ARCHITECTURAL REVIEW BOARD MUNICIPAL PLANNING COMMISSION -AGENDA-

Thursday, January 12, 2023 at 7:00 P.M.

MEMORANDUM

SUBJECT: Staff Memo for the Meeting of January 12, 2023

A-0.3

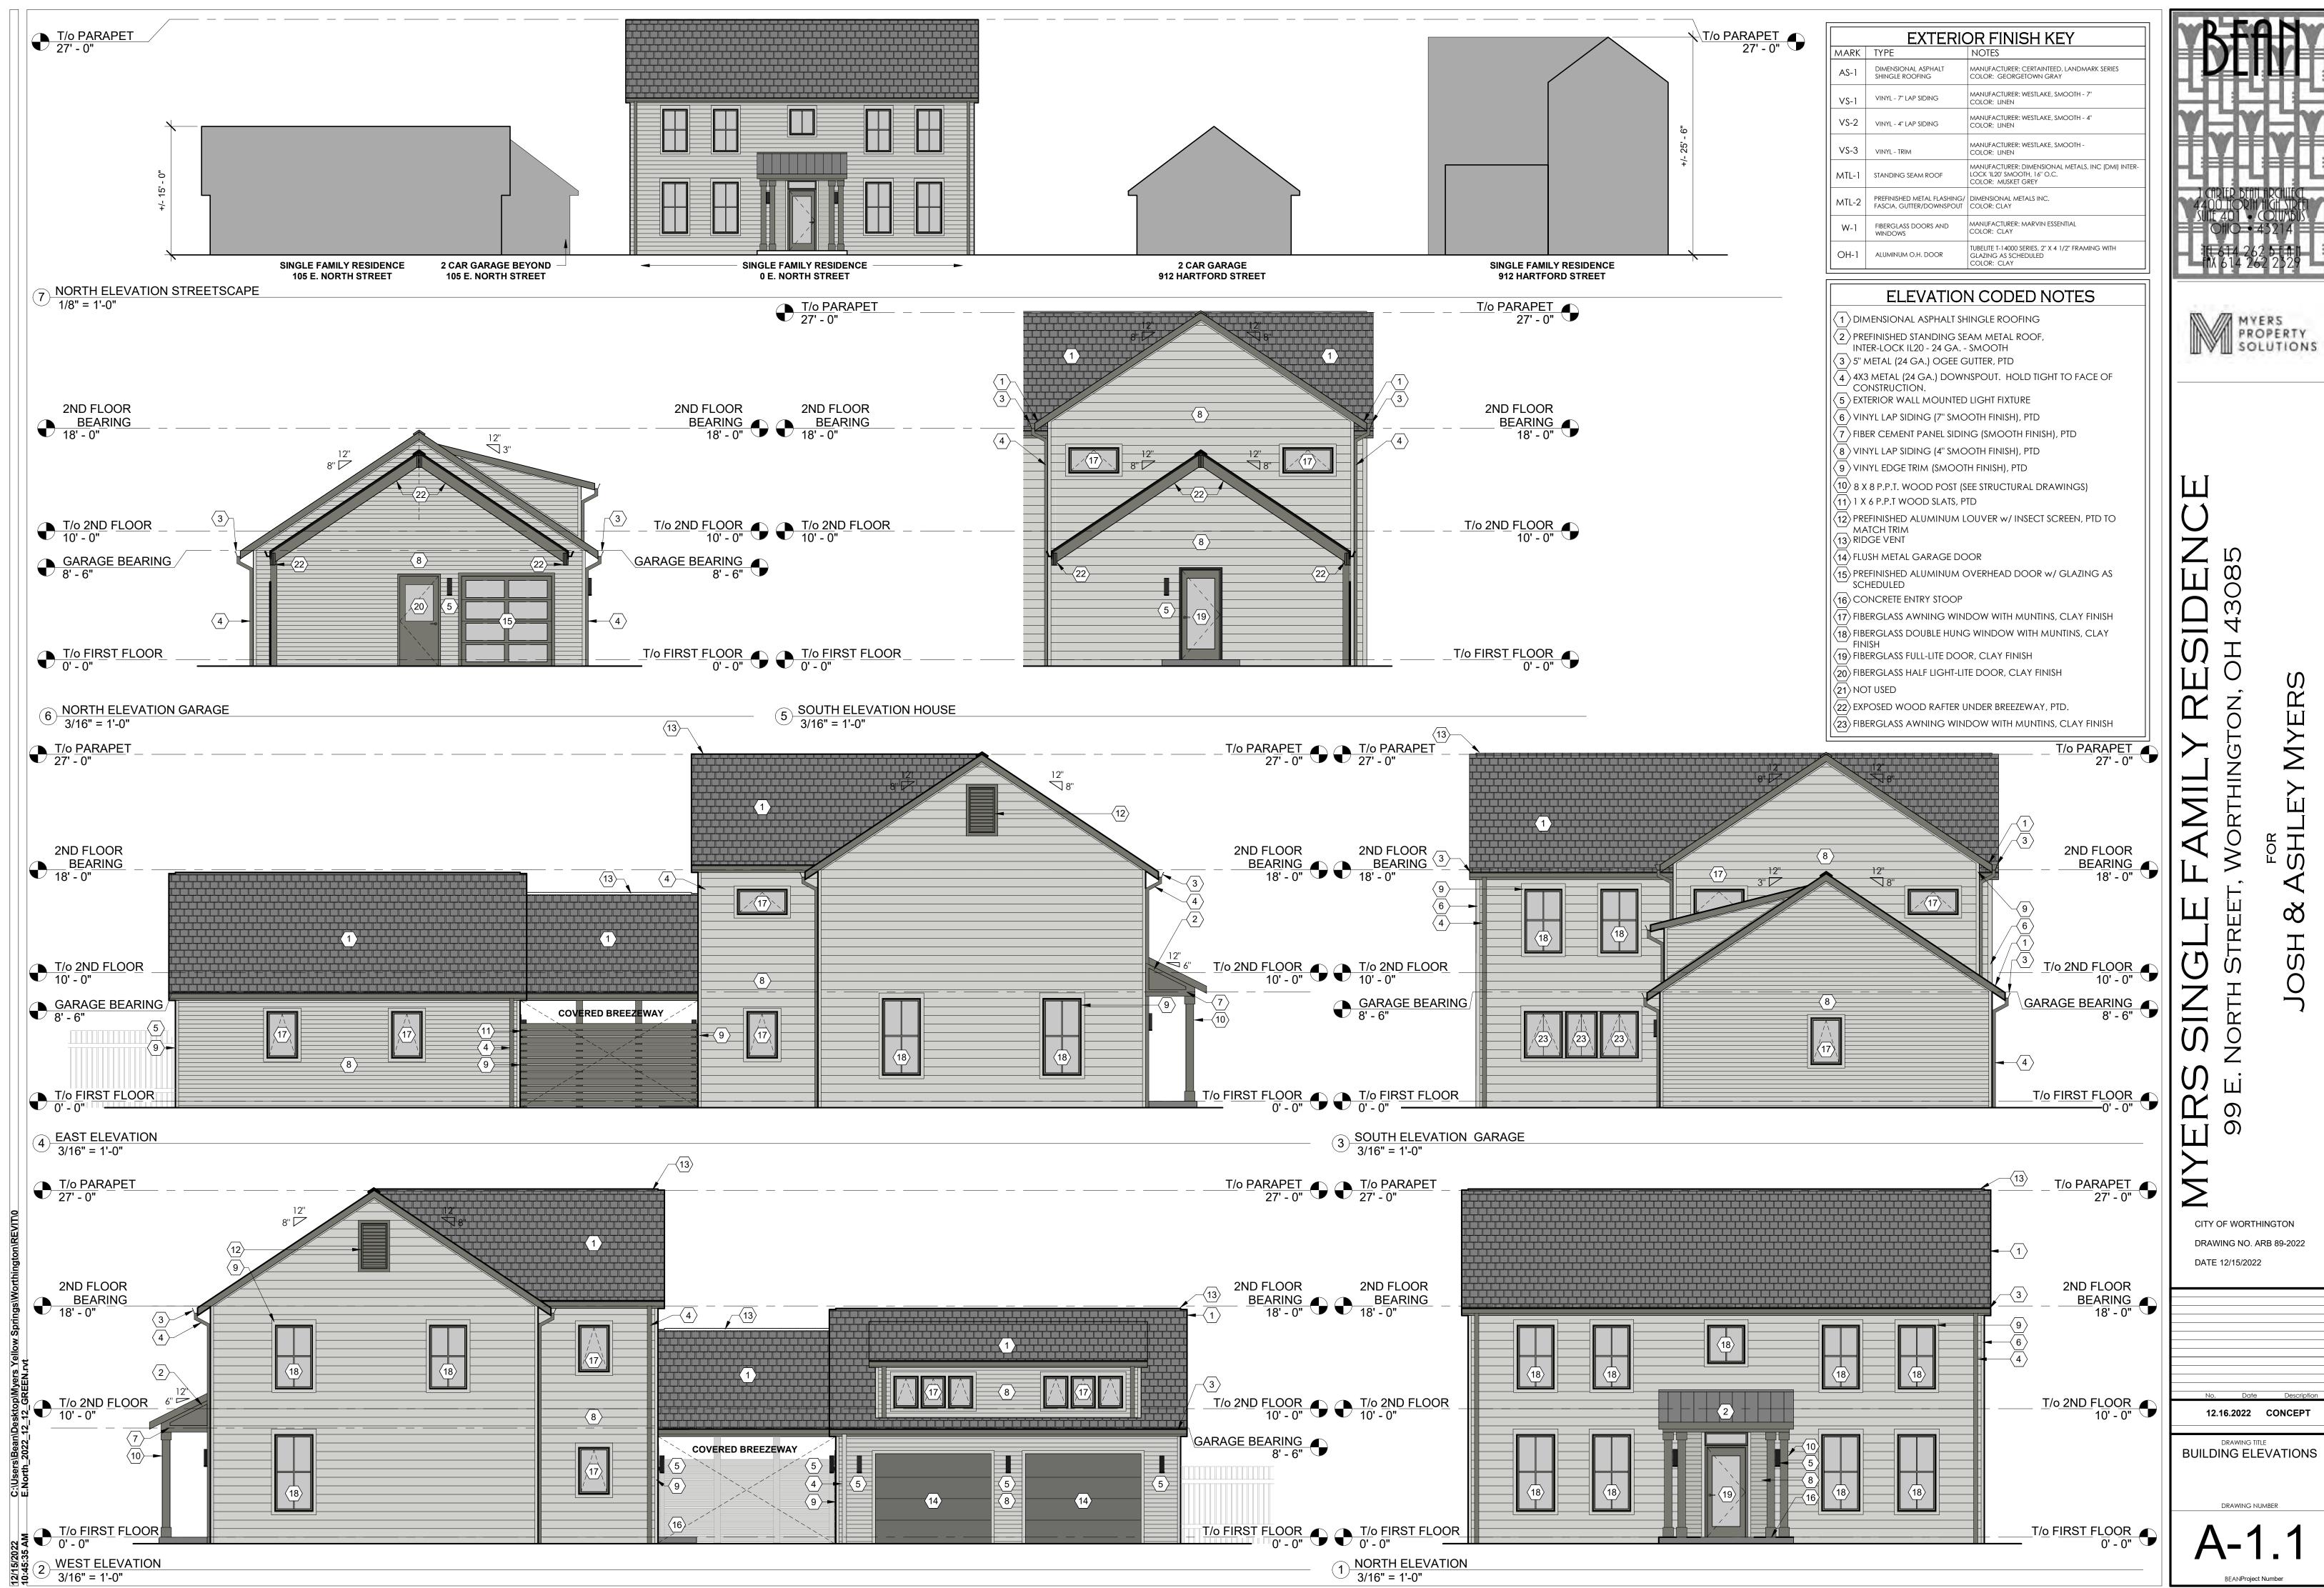
- 2. Landscaping:
 - a. An existing Sugargum tree is to remain at the front of the property on the east side.
 - b. Planting beds are proposed around the house with Barberry, Sneezy Rhododendron, Chinese Silver Grass, Lungwart and Astilbe Japonica Europa.

- c. Along the west side of the drive, the area from the front of the property to the house would be planted with Dwarf Fountain Grass and the portion across from the house would have Japanese Plum Yews.

- 6. The plans call for muntins in the awning windows, but the drawings do not show muntins.
- 7. The addition of landscape beds should help soften the building and help with storm water in the driveway area. The coverage with concrete is less than previously proposed.

PEDESTRIAN CIRCULATION

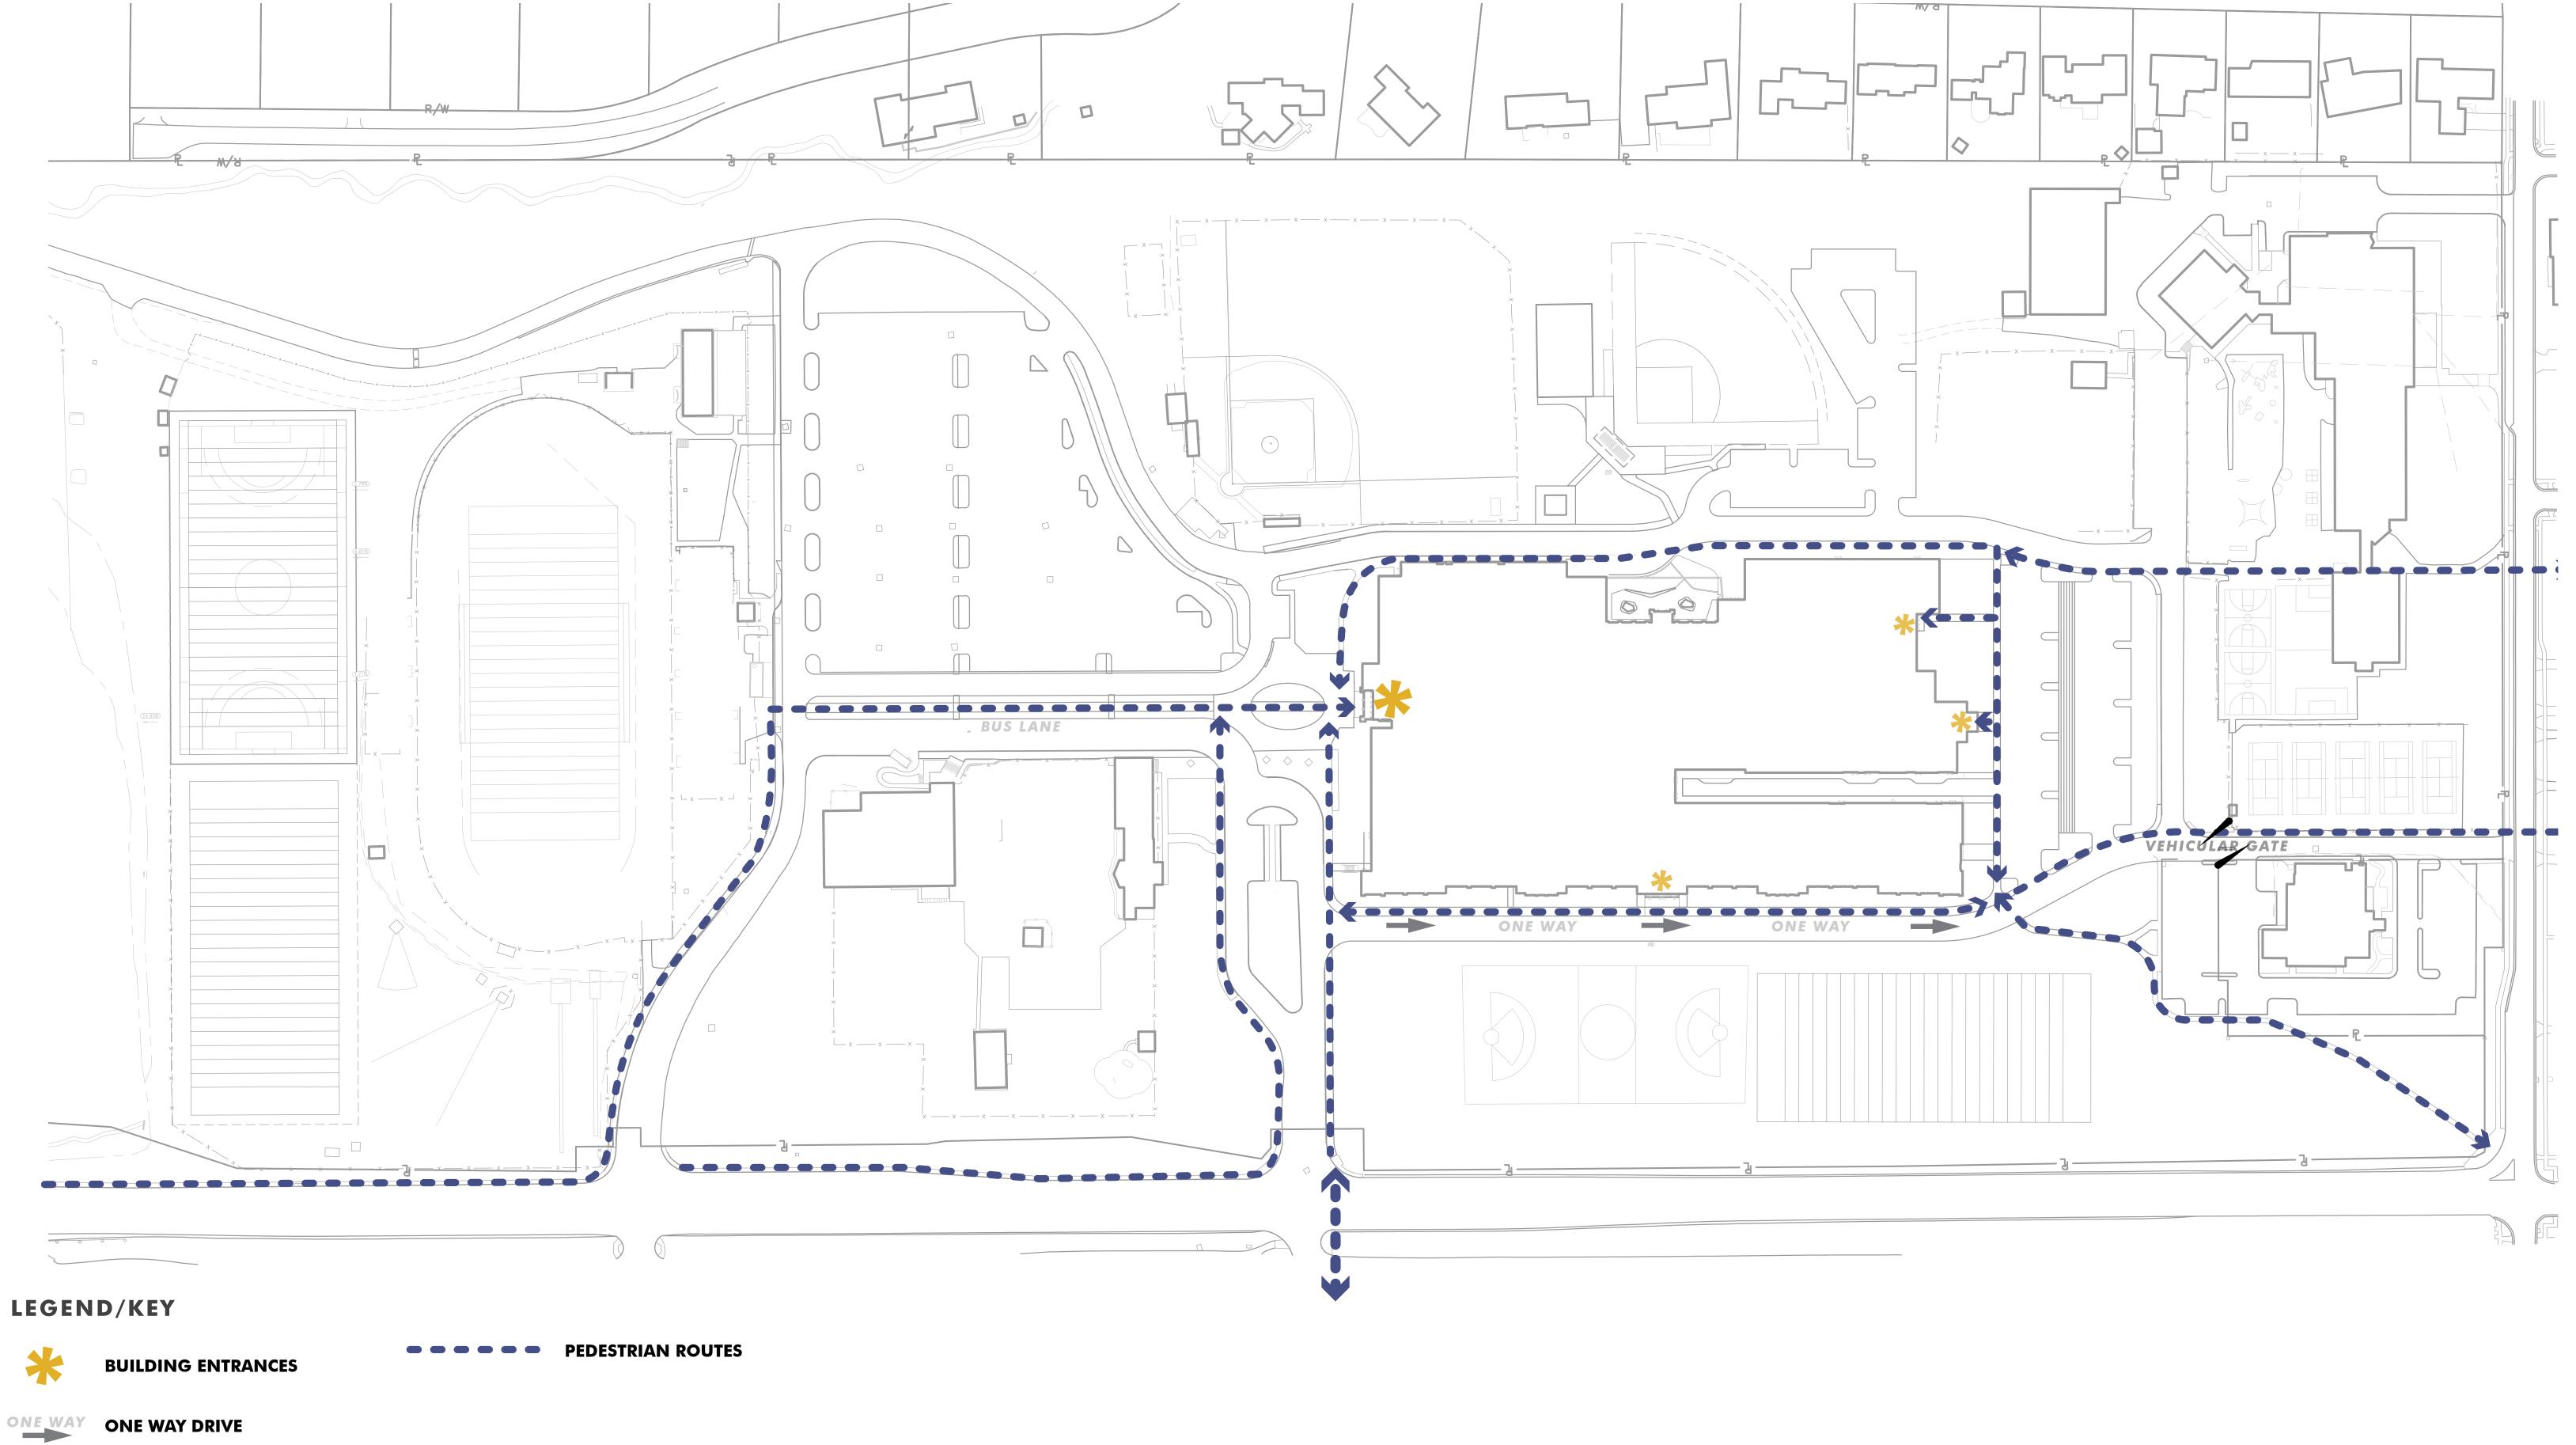
- 1. A shared use path along Dublin-Granville Rd. was identified as the highest priority active transportation project in Worthington's Bicycle and Pedestrian Master Plan. Staff recommends the applicant explore options to implement a shared use path into their pedestrian circulation plan.

- 4. Clarify how pedestrians would safely cross from the proposed sidewalk on the west side of the western school entrance to the "pedestrian promenade". Safe pedestrian crossing of Dublin-Granville Rd. at Seabury Dr. should also be explored.

- 6. Clarify how pedestrians would access the building from the easternmost parking lot. Would there be steps or a ramp to accommodate the change in grade?
